Tailwaters at Stagecoach Prelim Subdivision

ACTIVITY #:	PL20240006
HEARING DATE(S):	Planning Commission - January 16, 2025 Board of County Commissioners - February 4, 2025
PETITIONER:	TAILWATERS AT STAGECOACH LLC
PETITION:	Subdivision - Preliminary for 200 residential units and a commercial parcel
LEGAL DESCRIPTION:	LOTS 8, 9 5-3-84 SW4SW4 32-4-84 (REC 842000 & REC 842491) TOTAL 89.17 AC
LOCATION:	961052001 at the intersection of CR 16 & CR 18A
ZONE DISTRICT:	High Density Residential (current zoning) Commercial (approved for a portion)
AREA:	89.17 acres
STAFF CONTACT:	Alan Goldich, agoldich@co.routt.co.us
ATTACHMENTS:	<ul style="list-style-type: none">• Narrative• Lotting Plan• Landscape Plan• Parks• Referral Agency comments• Public comments

TYPICAL LARGE SINGLE FAMILY LANDSCAPE - SCREENING FROM COUNTY ROAD

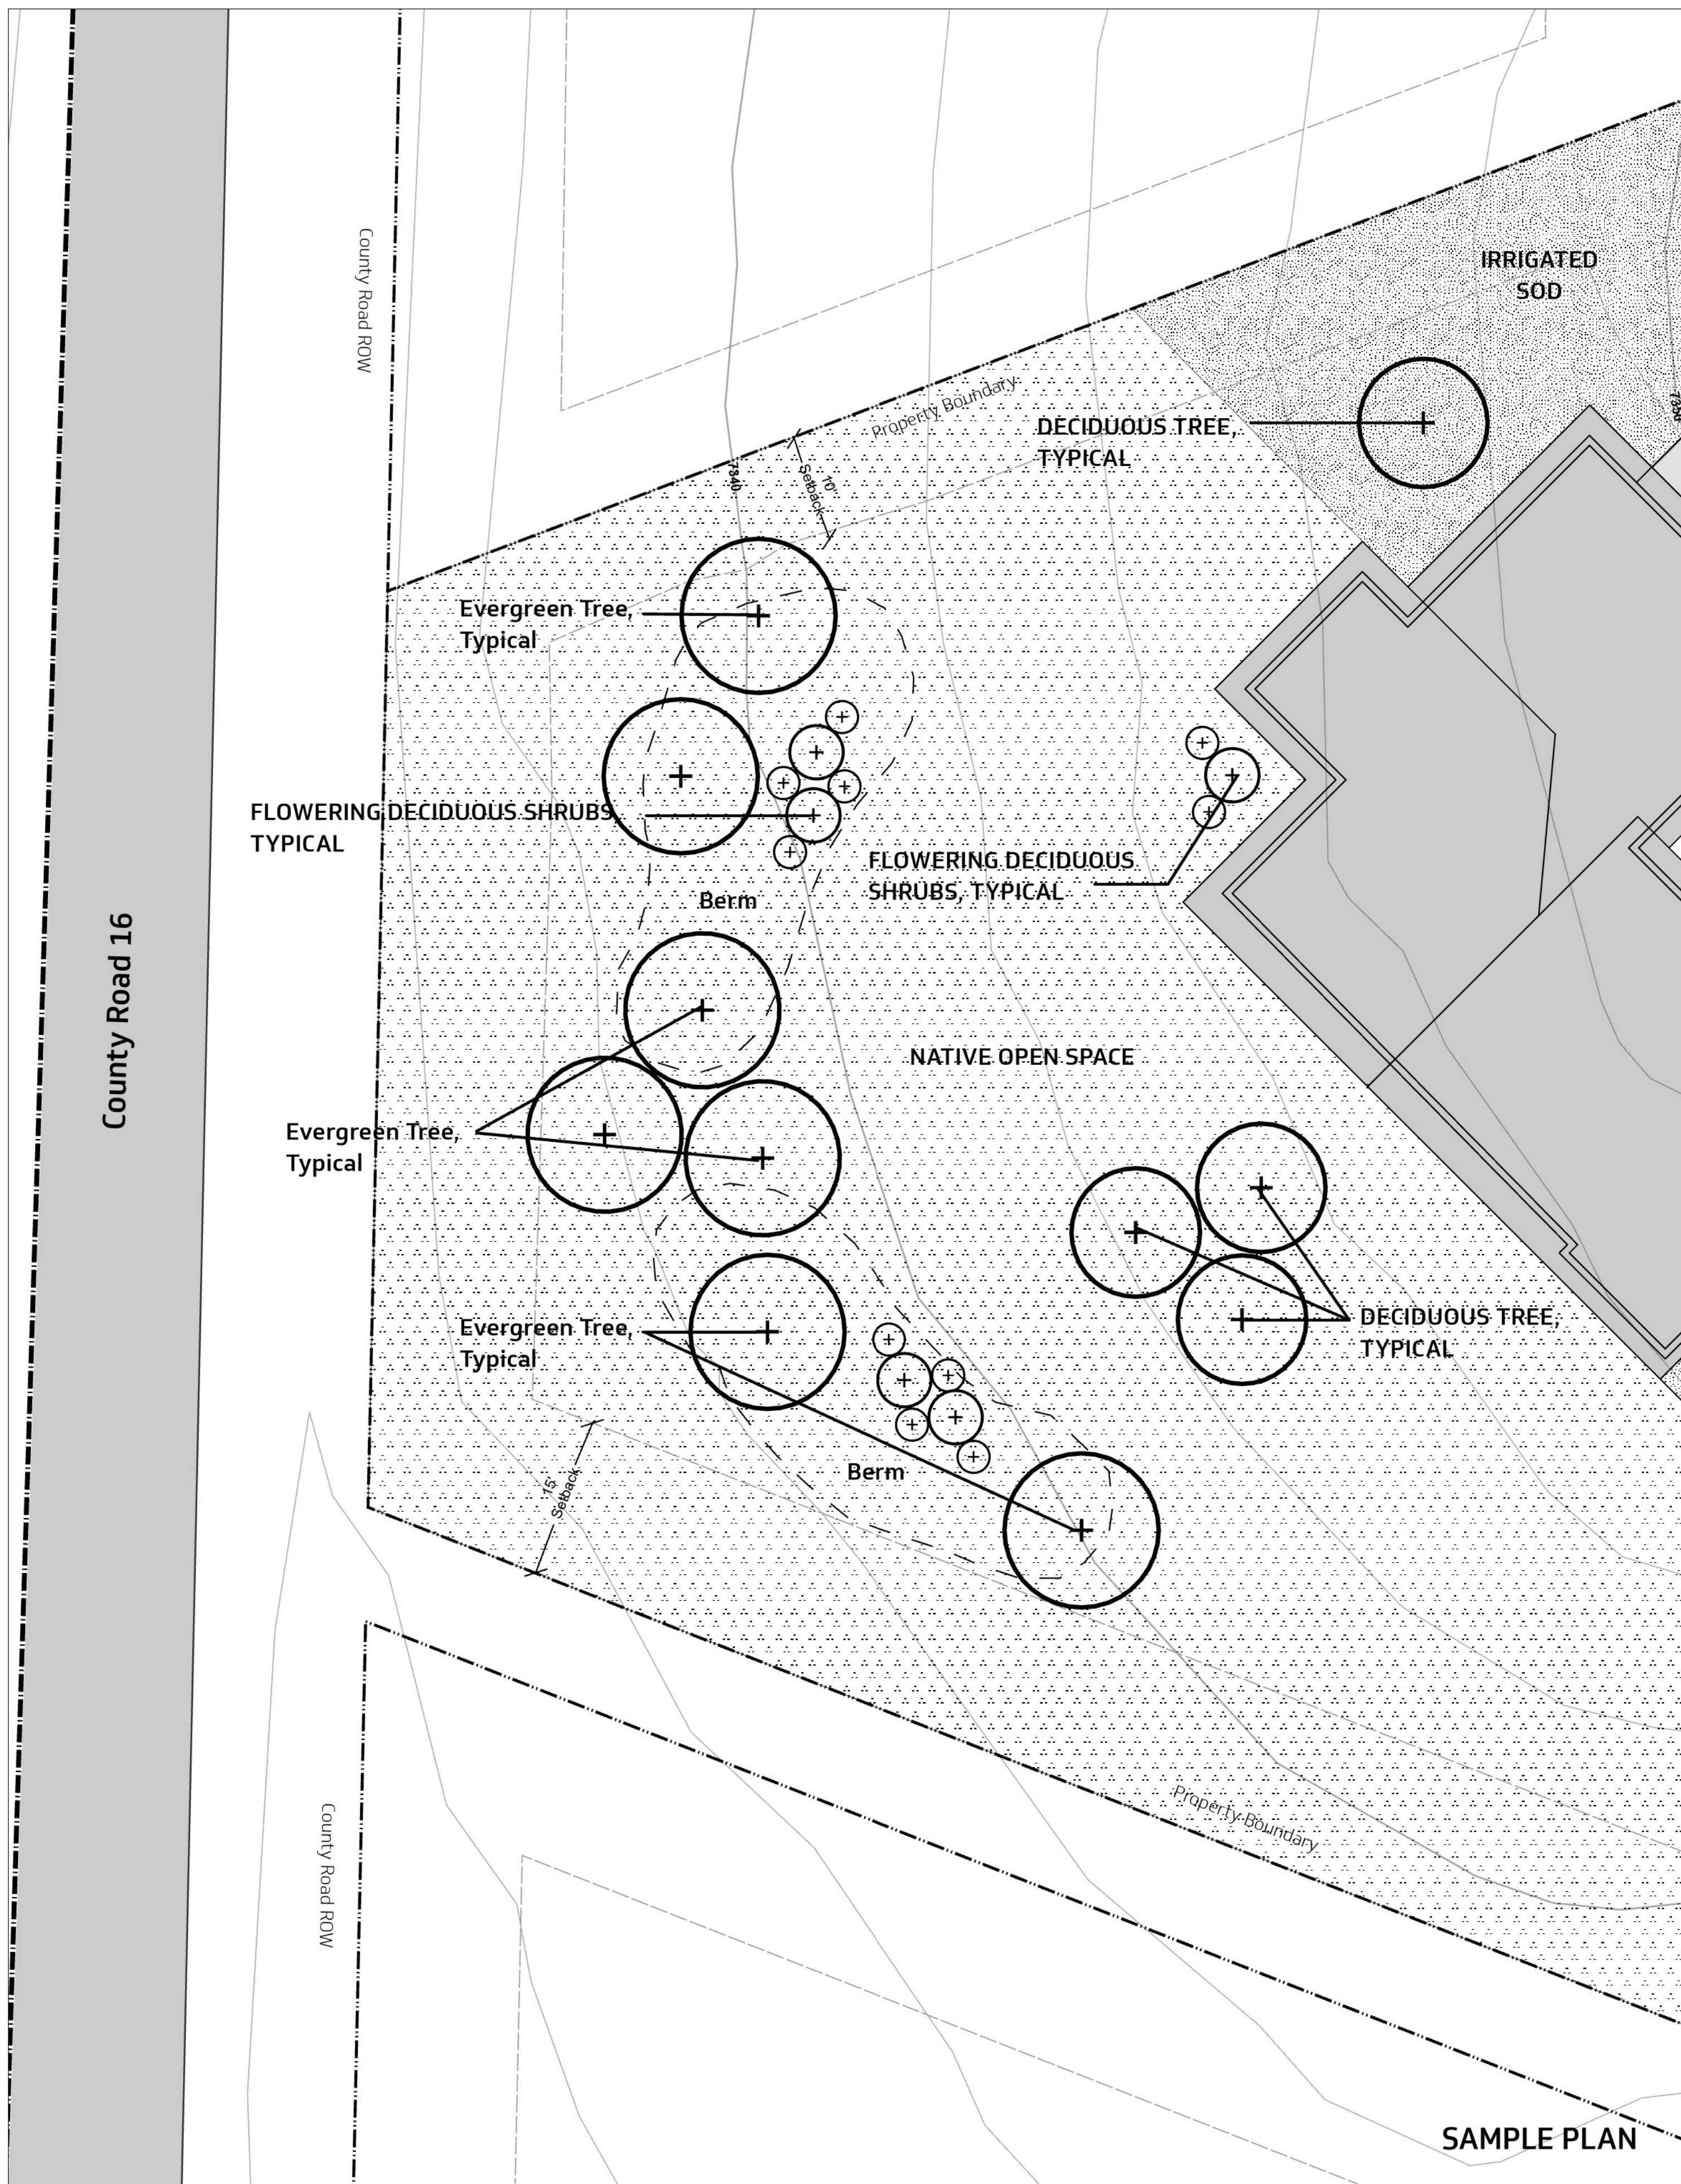
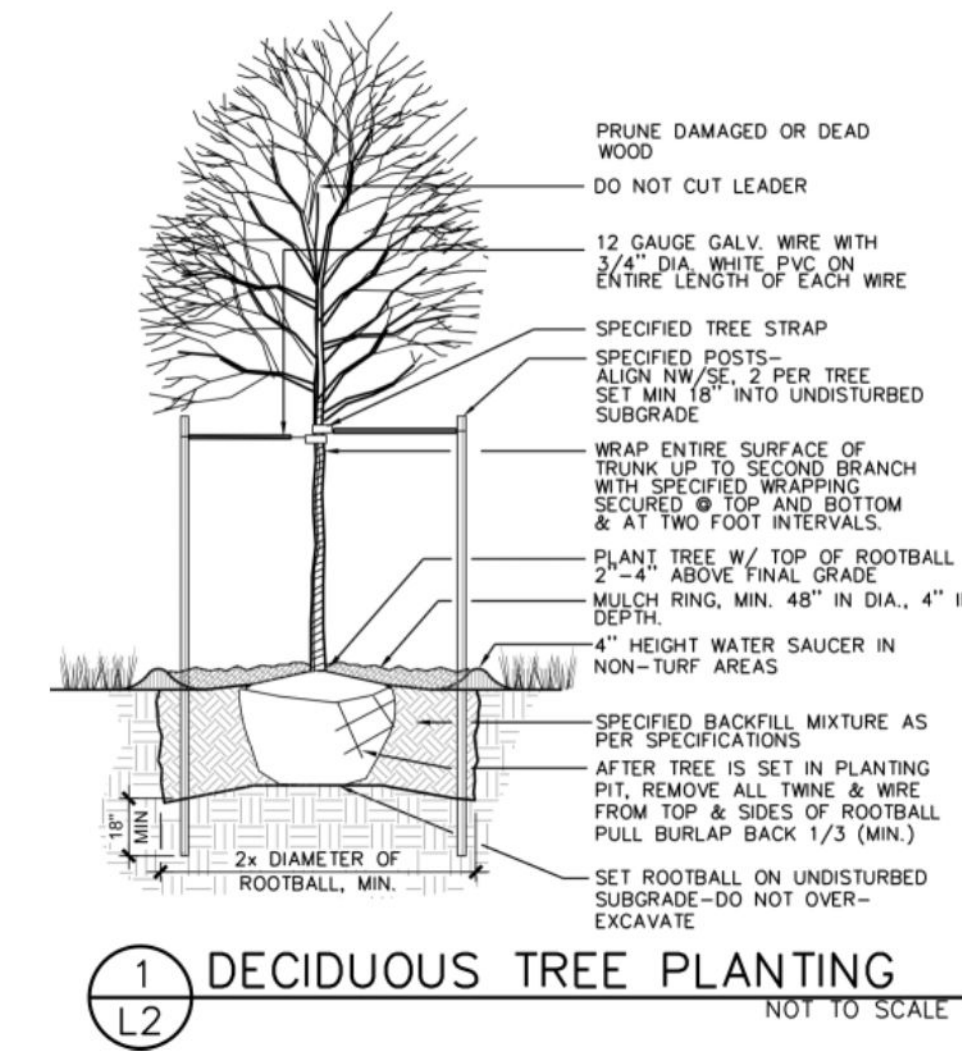
Most of the development will not be able to be seen from the county road, however the lots that are adjacent to CR 16 and 18A will be. The applicant has provided a typical detail of the landscape plan that will be required. What has been proposed will mitigate views of the development on these lots.

Staff comments: A construction phasing plan has been provided showing the progression of construction. The landscape plan will mitigate and soften views of the development from the county roads.

18. The typical residential landscaping detail dated October 1, 2024, shall be required to be adhered to by all residential lots that are immediately adjacent to County Roads 16 and 18A. Landscaping shall be installed prior to receiving a Certificate of Occupancy for the residence constructed on such lots.

Fig. 1. Pathways of water movement in a small patch. Nutrients can be carried in the water except in evaporation and transpiration.

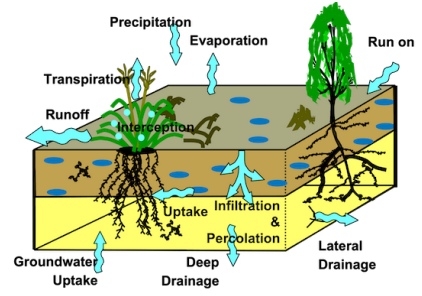
iii. *“Nutrients which could affect the health of Morrison Creek and Stagecoach Reservoir are transmitted almost exclusively through surface waters.”* This is an absurd statement that demonstrates the writer’s ignorance of soil science and hydrology. Figure 1 illustrates the pathways of water flow in soils above Little Morrison Creek. Much of the surface water will infiltrate into the soil and if that soil becomes saturated, the excess water will move downhill via lateral flow. Some may be lost from the soil to groundwater, but that water also may move laterally downhill.

Fig. 2. Pathway of water movement along and within hillslopes.

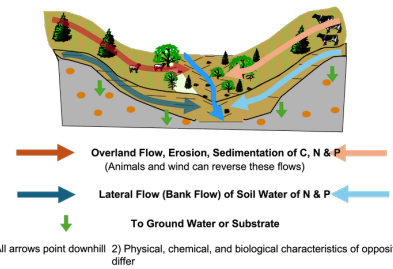
Water carries nutrients along these pathways. Given the aboveground parts of the current vegetation will be killed, the belowground living and dead parts, the microorganisms, and the belowground organic matter will be subjected to decomposition and release of nutrients that will be subject to loss downhill in lateral flow or downward to groundwater.

There is a large body of scientific literature and experience that recognize the quantities of nutrients in these belowground components are very significant and represent a flush that can substantial impact on stream and reservoir algae. In a broader landscape, water and nutrient flows are shown in Fig. 2. Many scientific studies have shown nutrient transport, especially Nitrogen, to be dominated by lateral flow or lateral drainage within the soil profile, especially when the surface soils have been drastically disturbed.
